DOCUMENT CHANGE REQUEST

DCR number 489	Changes required for: General	Originator: S Jeffery - ESCC
Date: 2009/04/14	Date sent: 2009/04/14	Organisation: ESA/ESTEC
Status: IMPLEMENTED

Title:	Transistors Low Power NPN, based on type 2N3700		
Number:	5201/004	Issue:	3

ESCC Detail Specification No. 5201/004

1.6.1 Metal Can Package (TO-18) - 3 lead

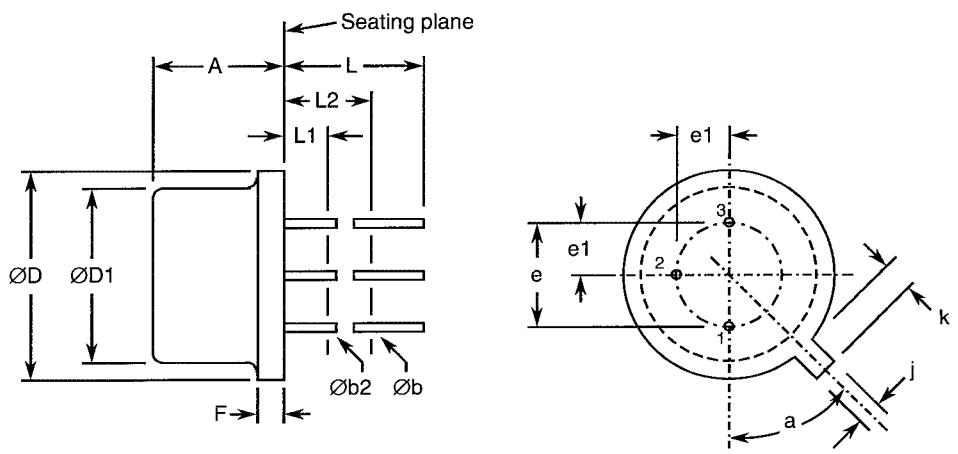
Note addition of horizontal lines

1.6.2 Chip Carrier Package (CCP) - 3 terminal

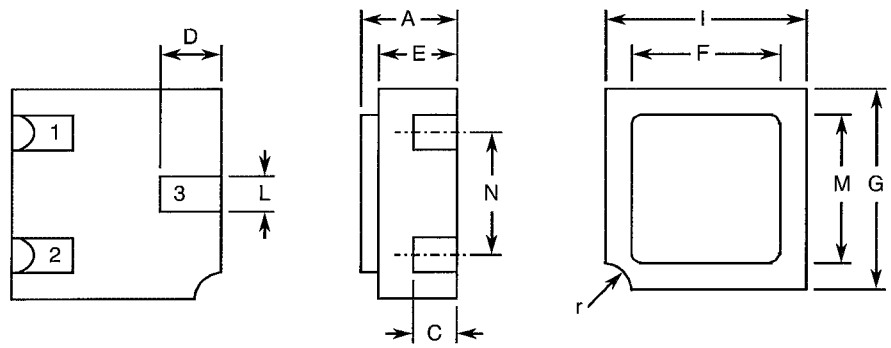
Note addition of horizontal lines

1.6.3 Chip Carrier Package (CCP) - 4 terminal

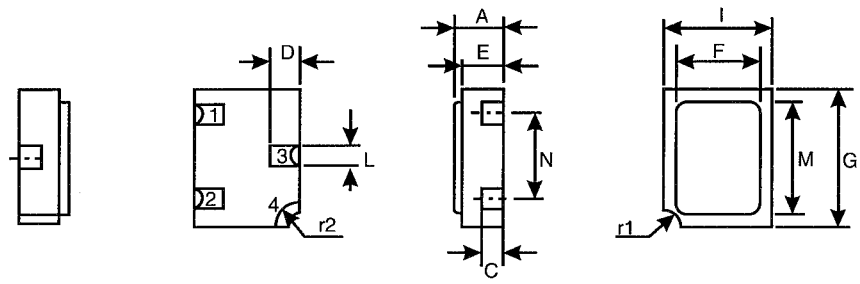
Note addition of horizontal lines

Note addition of horizontal lines
